# VARIANCE STAFF REPORT

Case No. and Project Name: VAR-20-58-2, Ulery Property

Requested Action: Variance to Land Development Regulations (LDR) Sections 6.01.04.A and 6.15.04(A), to allow for an accessory structure (pool, spa, deck, and/or pool enclosure) to be located 22.5-feet from the Normal High Water Line, in lieu of 50-feet.

# Attachment "A" – Plot Plan

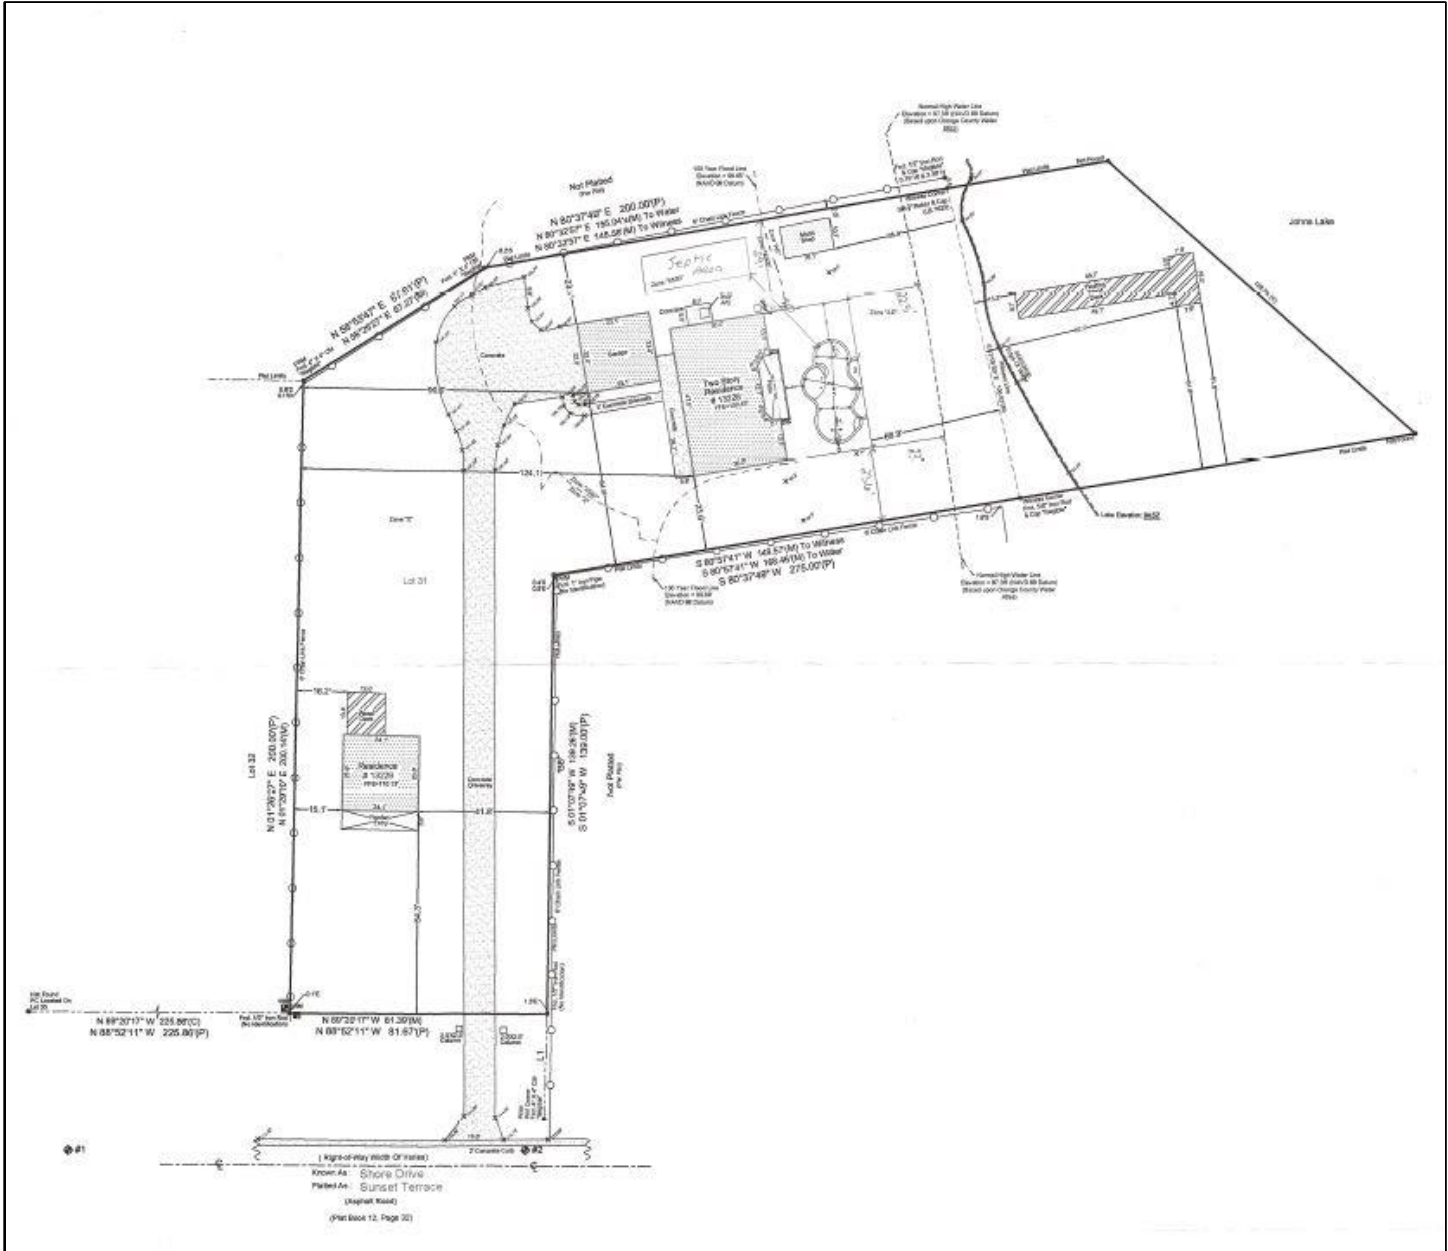
The plot plan (Attachment "A") depicts the location of the Normal High Water Line and proposed accessory structure. The Department of Public Works reviewed the variance application and identified the following conditions to be included in the development order, should the variance request be approved:

1. An interceptor swale that is sized to capture the first 1-inch of stormwater runoff shall be provided on site. An engineered design that includes a plan and calculations must be submitted with the permit applications for the interceptor swale.

2. Stormwater calculations must be reviewed and approved by the Lake County Public Works Department staff.
3. The stormwater abatement system must be depicted on the to-scale plot plan when applying for the zoning permit, installed prior to any final inspection, inspected and approved by the Lake County Public Works Department staff.

4. Compensating storage for fill within the floodplain will be required. An engineered design for the lot grading and flood compensating storage along with compensating storage calculations will be required at time of permitting.

5. Additional flood determination and permitting may be required during the site permitting.
